ALERT SERVICE BULLETIN

NO. 205B-08-50
DATE Dec 08, 2008
PAGE 1 of 7

MODEL AFFECTED: 205B

SUBJECT: STARTER/GENERATOR POWER CABLE, UPGRADE.

Figure 1
Structural Modification

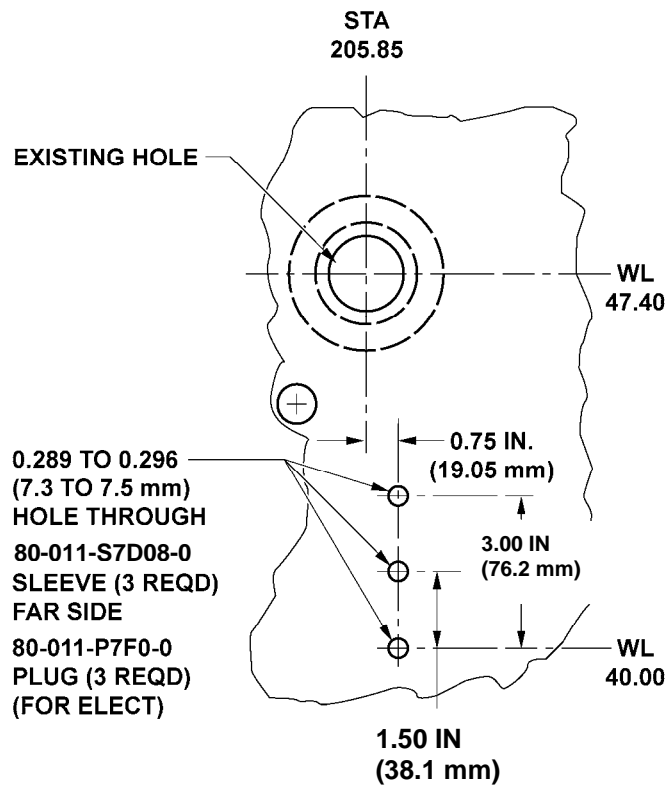
- 4) Remove wires as per Table 1. Retain hardware for re-installation.
 - 5) Install plugs and sleeves as follow:
 - a) Locate qty 3 holes in accordance with Figure 1.

- b) Drill qty 3 holes 0.296 to 0.289 inch through panel assembly as shown on figure 1.
 - c) Install qty 3 sleeves P/N 80-011-S7D08-0 far side and plug P/N 80-011-P7F0-0 using adhesive C-317 as detailed in Structural Repair Manual (SRM).

- d) Allow adhesive to cure.
 - 6) Install terminal board P/N MS27212-5-2, TB 150, on inboard side of main beam at STA 205.10 using qty 3 screws MS35206-233, qty 3 washers AN960PD6L, and qty 3 nuts NAS679A06.

Figure 2
Wiring Diagram

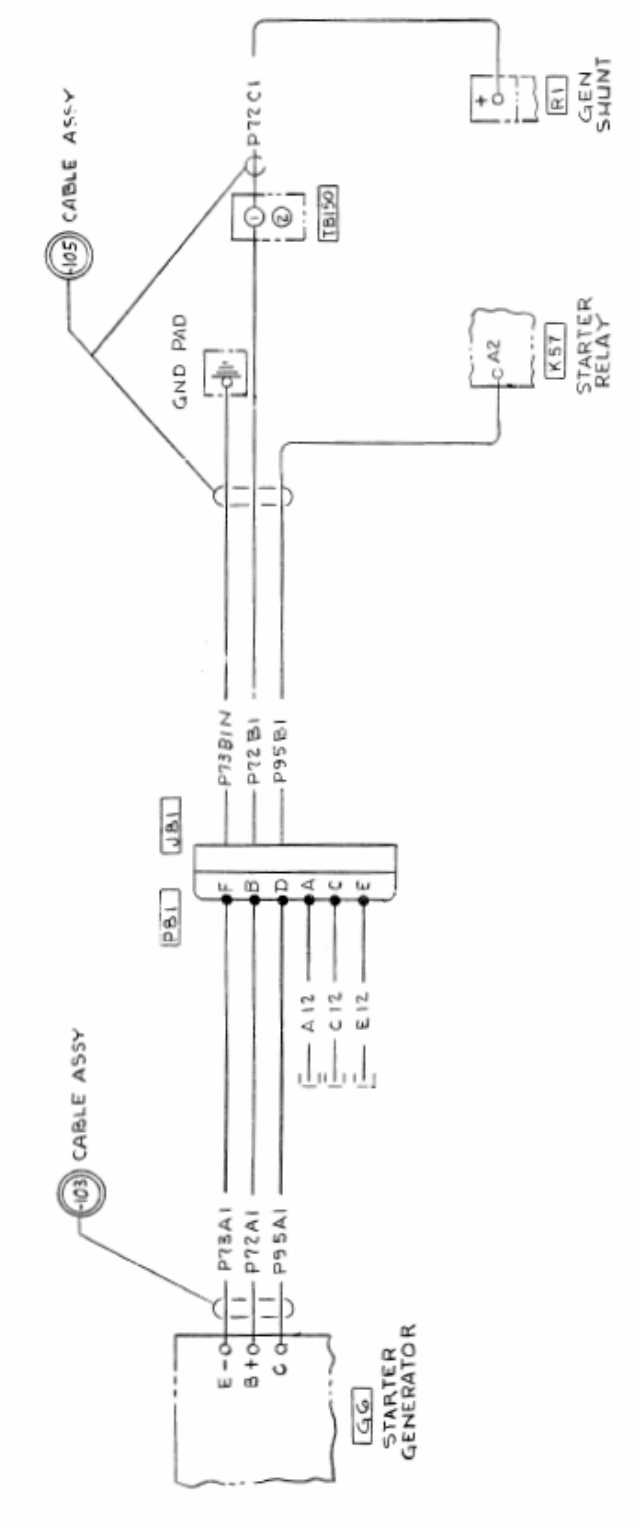
Reference to Figure 2 for the following steps.

- 9) Prepare ground pad for electrical bonding per BHT-ELECT-SPM. Connect wire P73B1N to ground pad using retained hardware.
- 10) Connect wire P95B1 to K57 (starter relay) terminal A2 using retained hardware.

- 11) Connect wire P72B1 and P72C1 to TB 150, terminal 1 using strip P/N MS3373-A3, strip P/N MS3373-C3, qty 2 washer P/N AN960D616L and nut P/N MS21042L6.

- 12) Install cover assembly P/N MS18029-5S-2 on TB 150.
- 13) Connect the other end of wire P72C1 to R1 (Generator Shunt) on the + side as follows:
 - a) Route wire P72C1 to R1 (Generator Shunt).

- b) Cut wire P72C1 and install terminal lug P/N MS25036-130 using crimper MS 25441 with die MS 23002-1.
 - c) Connect wire P72C1 to R1 (generator Shunt) on + side using retained hardware.
